# UNITED STATES PATENT AND TRADEMARK OFFICE

APPLICATION NO.	FILING DATE	FIRST NAMED INVENTOR	ATTORNEY DOCKET NO.	CONFIRMATION NO.
10/809,341	03/26/2004	Atsuhisa Nakashima	119262	8238
25944	7590 06/12/2006		EXAM	INER
OLIFF & BERRIDGE, PLC			MRUK, GEOFFREY S	
P.O. BOX 19928 ALEXANDRIA, VA 22320			ART UNIT	PAPER NUMBER
			2853	
			DATE MAIL ED. 06/12/2004	DATE MAILED: 06/13/2006

**DETAILED ACTION**

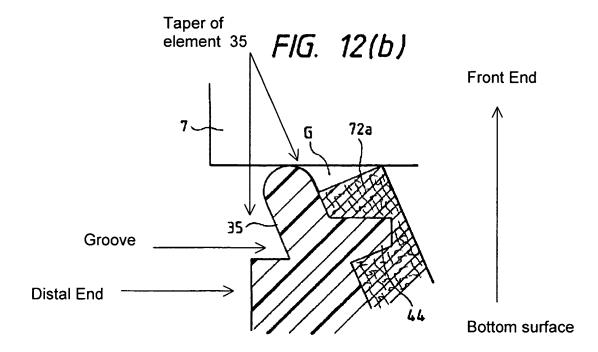
With respect to claim 4, Takahashi discloses each of the side lips (Fig. 7a, element 35b) has a front end and is formed into a tapered sectional shape which is smaller in width as a location goes from the bottom surface toward the front end (See Fig. 12b below); and the corner lip has substantially the same height (Column 6, lines 45-48, i.e. sealing the recording head) as the side lips and is smaller than the side lips in thickness (Column 6, lines 11-19; Claim 12).

With respect to claim 6, Takahashi discloses the ring-like lip includes a distal end (See Fig. 12b below) and a groove (See Fig. 12b below) that urges the distal end to be deformed in an outer side of the ring-like lip (Fig. 12b, element 35).
